PLAN REVIEW CENTER REPORT

PRO Concept Plan: Consideration of Eligibility

Rezoning Request from RC Regional Center to B-3 General Business with a Planned Rezoning Overlay

Review Date: March 18, 2024
Review Type: Initial PRO Plan
Project Name: JZ24-02 JAX KAR WASH (44475 Twelve Mile)
Plan Date: February 9, 2024
Prepared by: Lindsay Bell, Senior Planner
Contact: E-mail: lbell@cityofnovi.org; Phone: (248) 347-0484

ORIGINAL ISSUE DATE:
FEBRUARY 9, 2024
DRAWING TITLE
LANDSCAPE CALCULATIONS

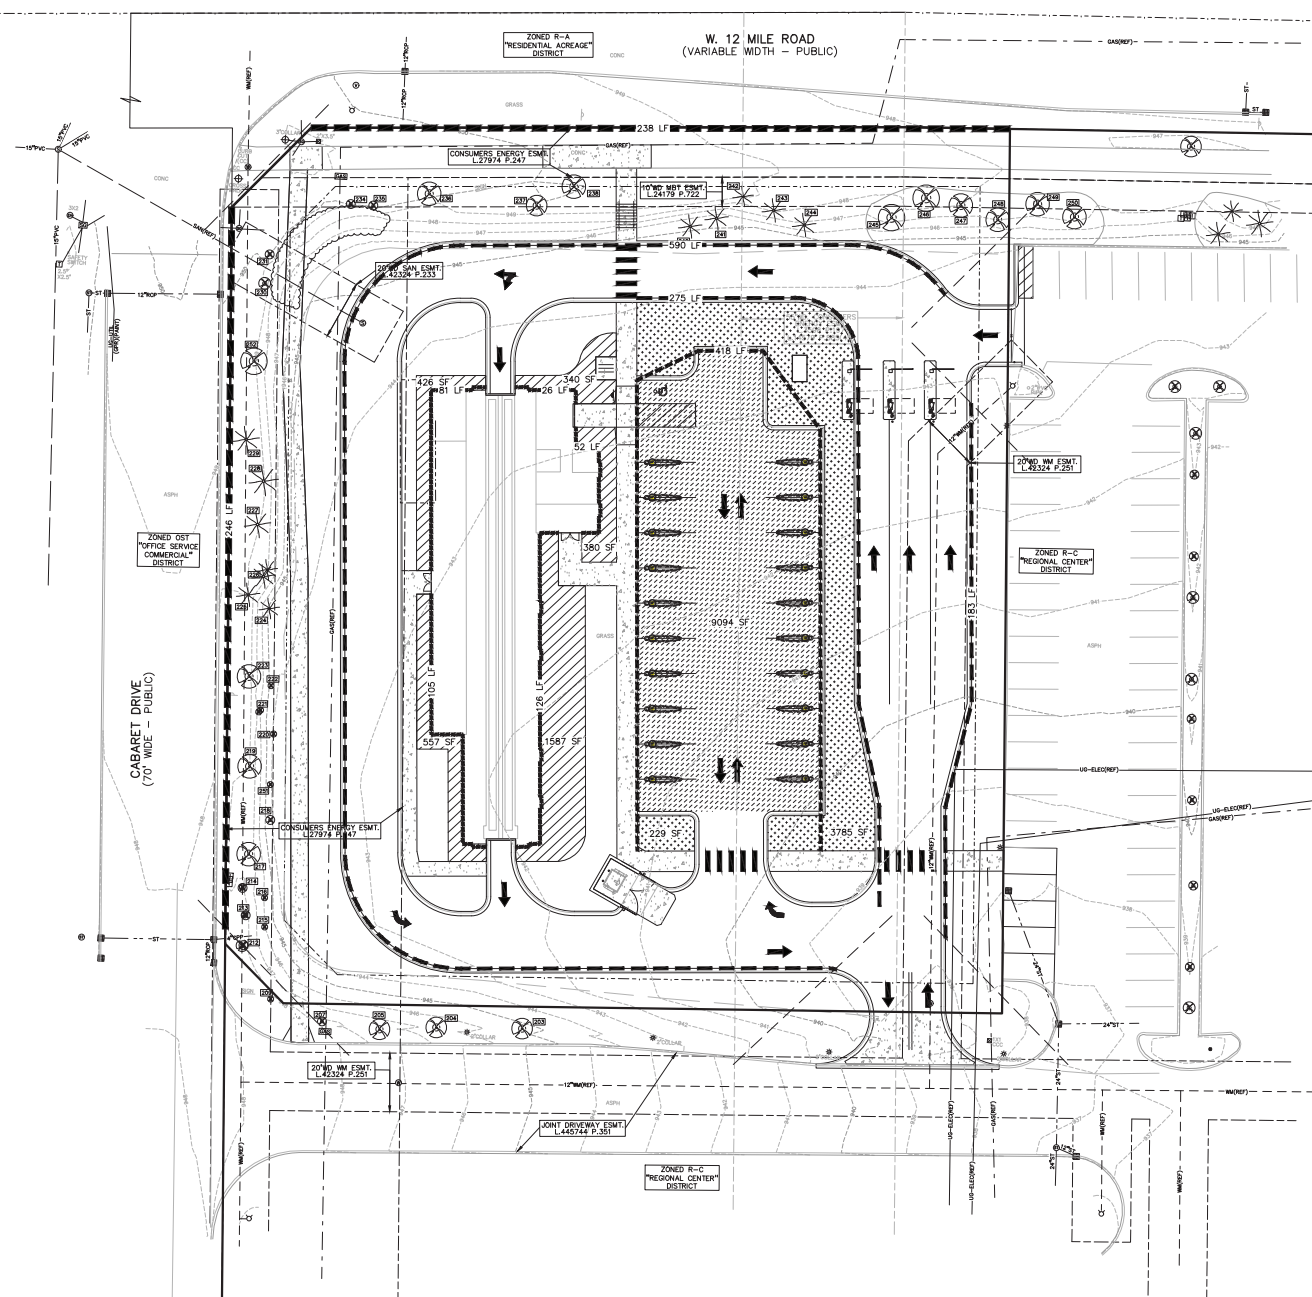
- Deficiency in accessway perimeter plantings – *not supported by staff unless the utility easement does not allow plantings along the west edge of the west bypass lane.*

1. While the required parking lot interior landscape areas and trees appear to be provided, rearrangements of utilities and trees are required to meet the ordinance requirements.
2. **See the detailed discussion of parking lot landscaping on the landscape chart.**
3. The required number of accessway perimeter trees is not proposed. An existing DTE easement may make it impossible to provide all of the required trees but that information needs to be provided to show that that is the case. **As it is, the deficiency would require a landscape deviation that would not be supported by staff. See the discussion of the issue on the Landscape Chart.**

- Reducing the impact of grading on existing plantings will be maximized as much as possible.
- Soil information is located on sheet C-3.0.
- Utilities, structures, and restrictions of easements are indicated on the Landscape plans.
- Proposed lighting shall be shown on the Landscape plans and will avoid conflict with trees.
- Trees shall be 10' minimum from hydrants, catch basin, manholes and sanitary sewer.
- The easements shall determine the required spacing of proposed trees. Trees will be located outside the utility easements.
- Snow deposit areas shall be smaller in size shown on the Landscape plans.

PRELIMINARY OVERALL FLOOR PLAN
SCALE: 1/8" = 1'-0"

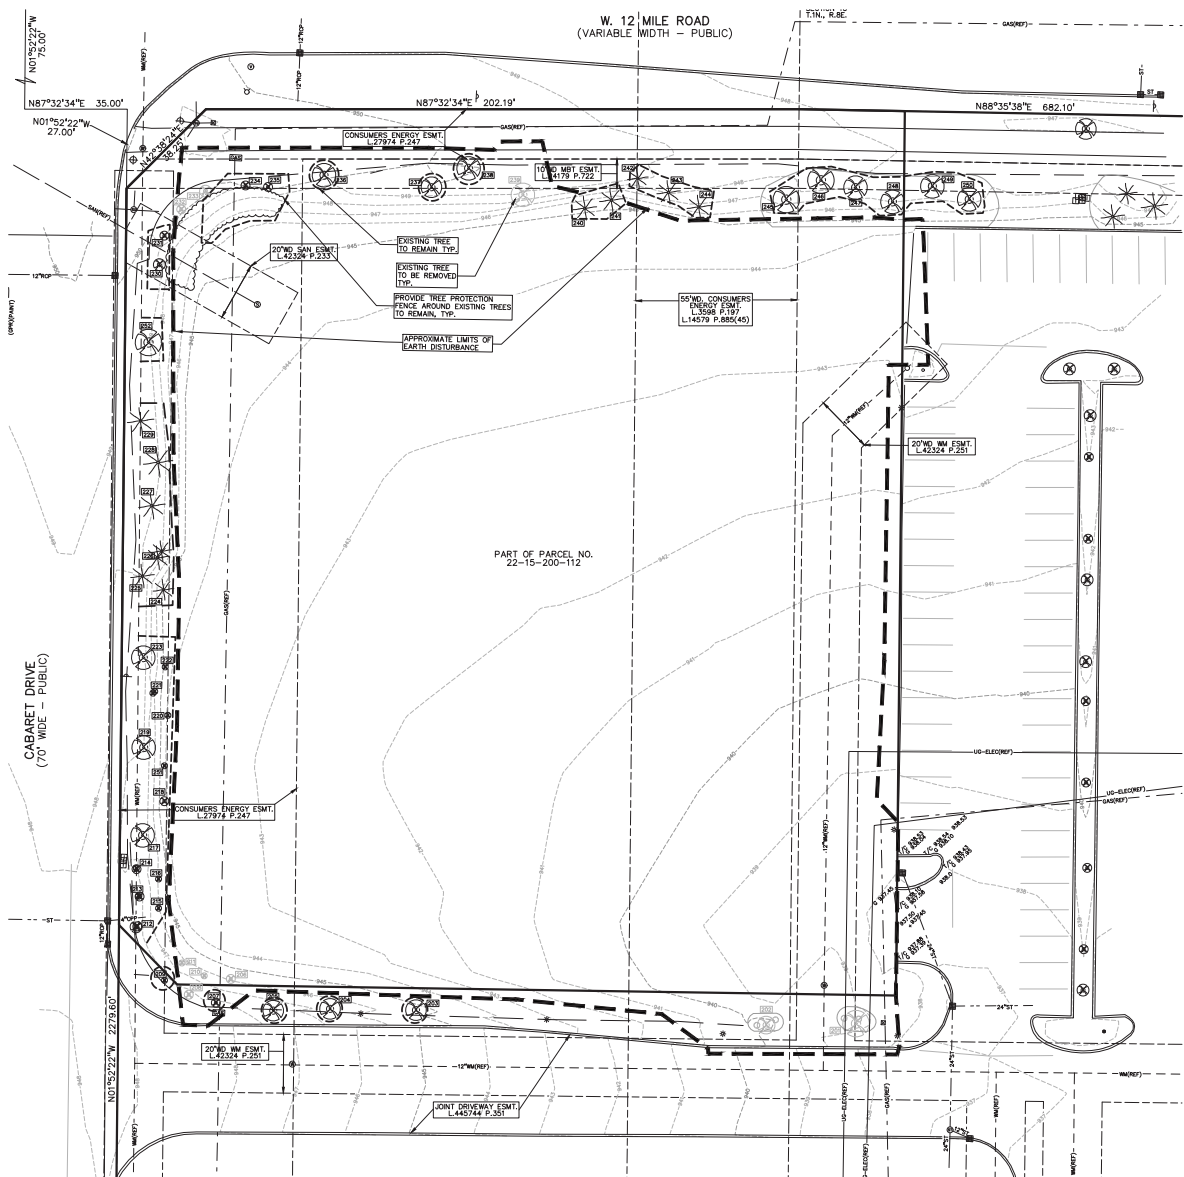
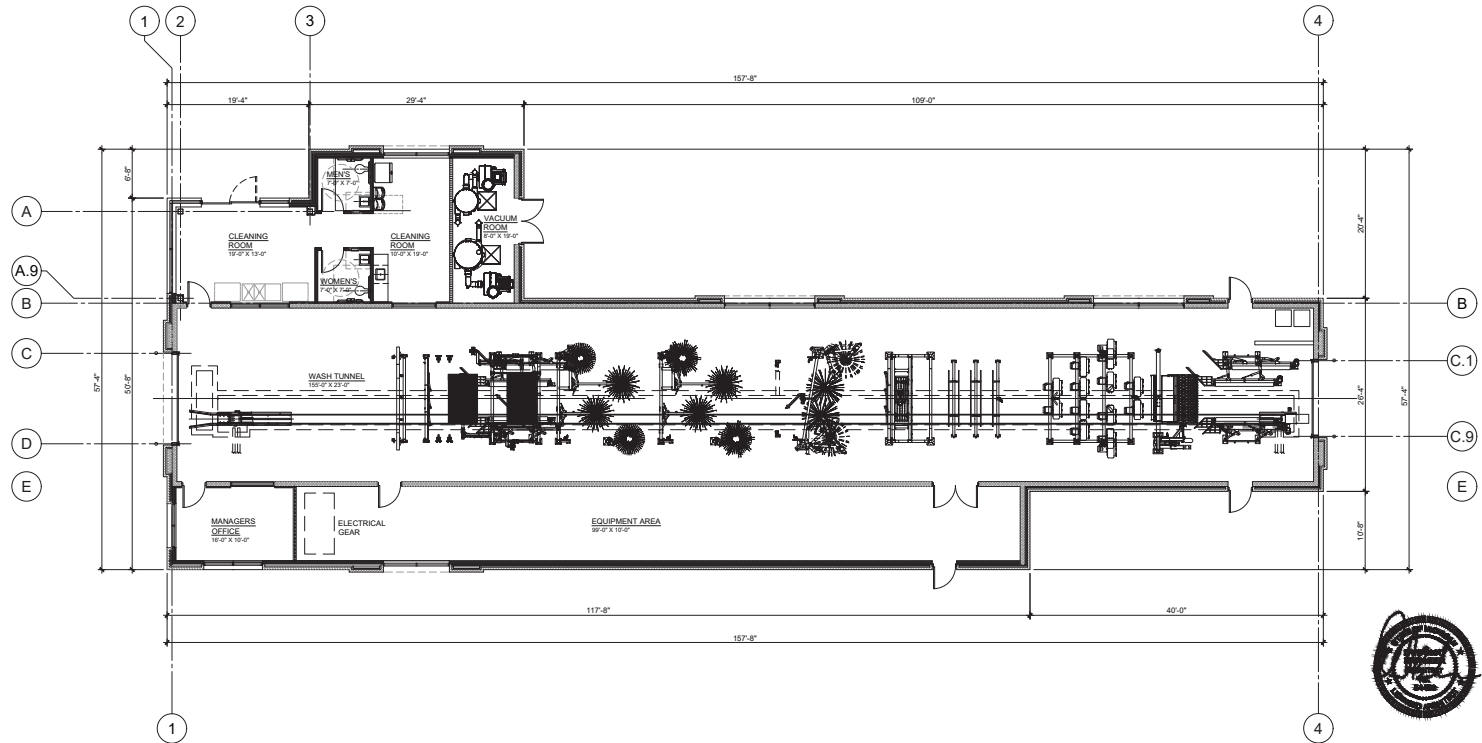
4. Exterior lighting (Section 5.7): A lighting and photometric plan is provided for the Residential portion of the project only. Calculations and ratios for lighting should exclude any unlit portions of the site (0.0 fc levels). **A deviation may be required if the 4:1 ratio cannot be achieved. See additional lighting comments in the Plan Review chart.**

- The proposed vacuum system is located within the proposed building, see sheet PFP-1 for details.
